Site Boundary Expansion Project Modification

Humboldt Bay Generating Station
(06-AFC-07C)

Submitted to:
California Energy Commission

March 17, 2023

Figure 1
Project Boundaries
 PG&E Humboldt Bay Generating Station
 Humboldt County, California

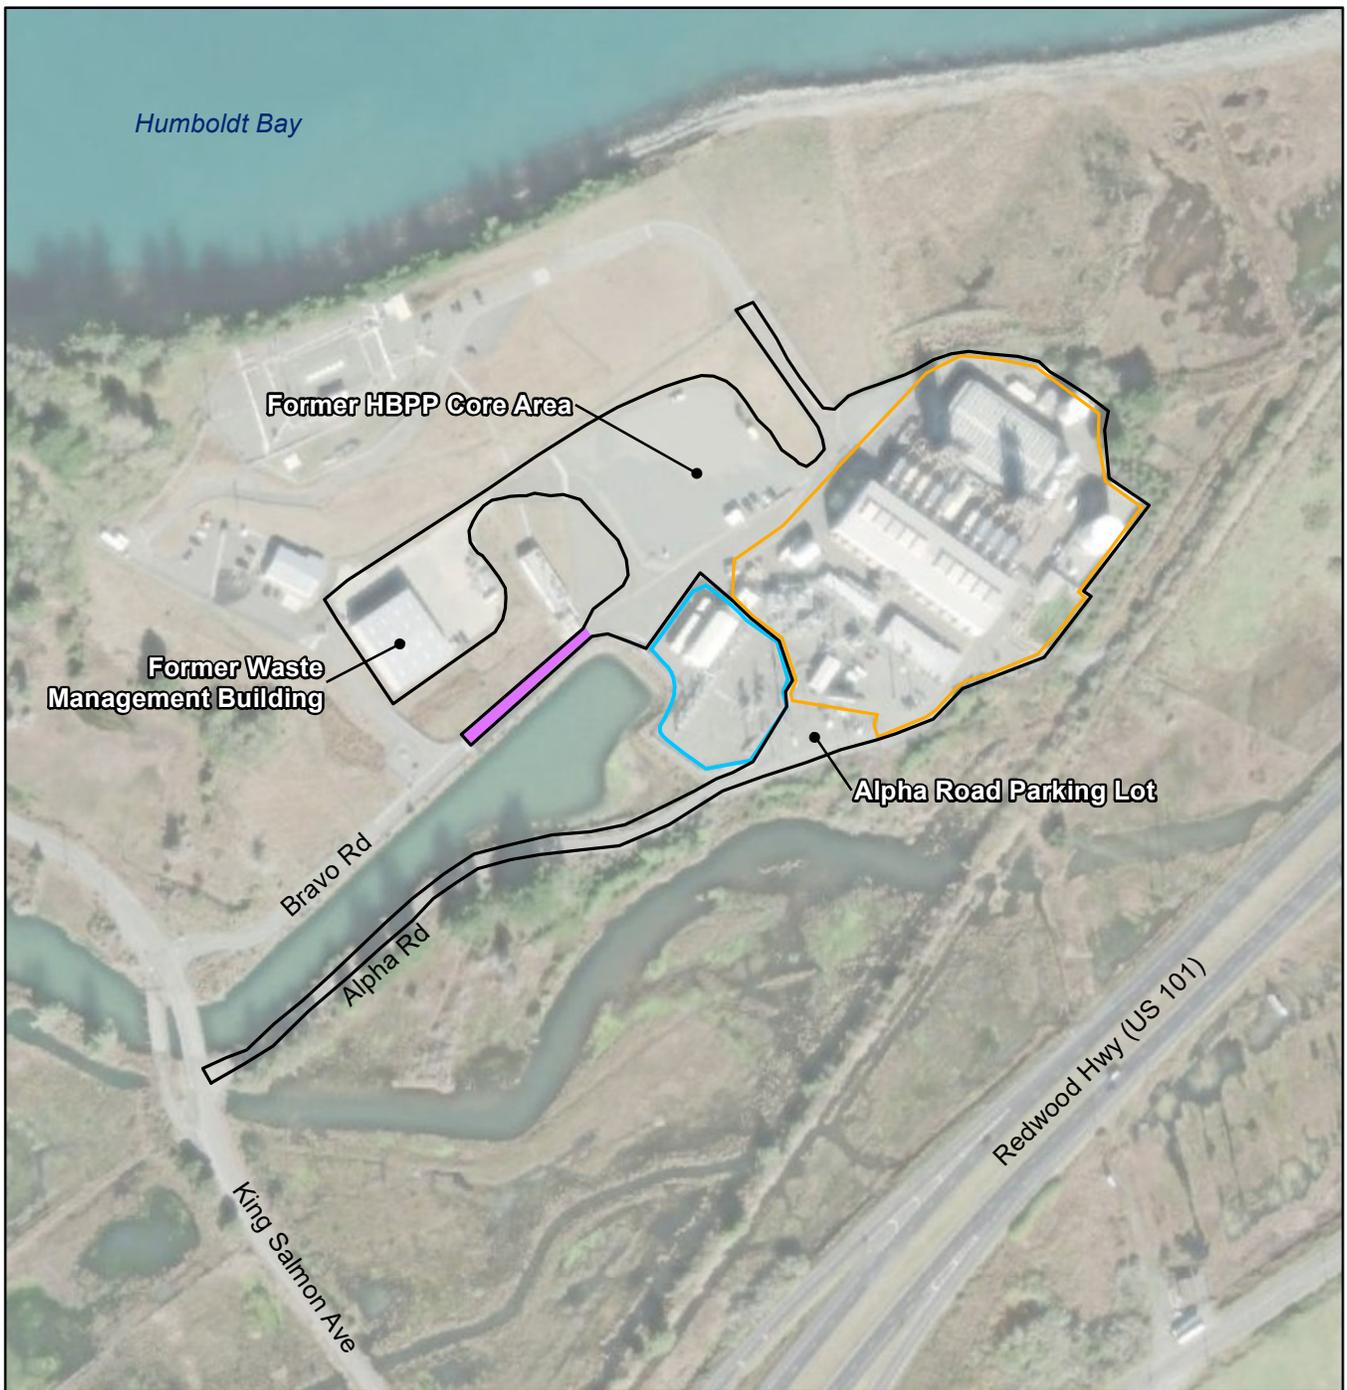
The purpose of this Petition to Amend (PTA) is to modify the HBGS CEC-jurisdictional site boundary now that the HBPP decommissioning, and site remediation and restoration are complete. The proposed modified boundary, shown in Figure 1, will provide HBGS space for maintenance laydown, storage, and parking. The boundary expansion will also enable HBGS to use HBPP infrastructure that was developed for decommissioning. As shown in Figure 1, primary plant access will be from Alpha Road. Bravo Road, which is currently the primary access road, will be a secondary and emergency access road and will include a secured electronic gate that is shared with ISFSI personnel. ISFSI personnel will use the gate and a portion of Bravo Road to access their training facilities (formerly Building 6) as well as existing ISFSI administrative facilities to the north of HBGS. All ISFSI facilities, including the training facilities, are located outside of the modified HBGS site boundary, with the exception of the approximately 250 feet of Bravo Road which will be shared by both HBGS and ISFSI. All habitat/wetland restoration areas associated with HBPP restoration requirements are outside of the proposed HBGS modified boundary.

The proposed modification to expand the HBGS site boundary will increase the size of the 5.4-acre HBGS site by approximately 4.6 acres, for a total of approximately 10 acres. The area within the boundary expansion will enable HBGS to operate more efficiently by providing adequate warehouse space, an area for maintenance/outage laydown, parking, and storage, as well as primary and secondary access routes. Figure 1 depicts the existing project features which will be included within the modified boundary. Each of these features and uses are discussed below.

In a compliance filing pursuant to Condition of Certification TRANS-3, PG&E stated that HBGS operations personnel would park in the Assembly Building parking lot adjacent to Bravo Road. As part of this Petition, the expansion of the boundary will include an existing parking area adjacent to Alpha Road and the security gate for HBGS (see Figure 1). This parking area will enable HBGS personnel and contractors to park closer to the power plant.
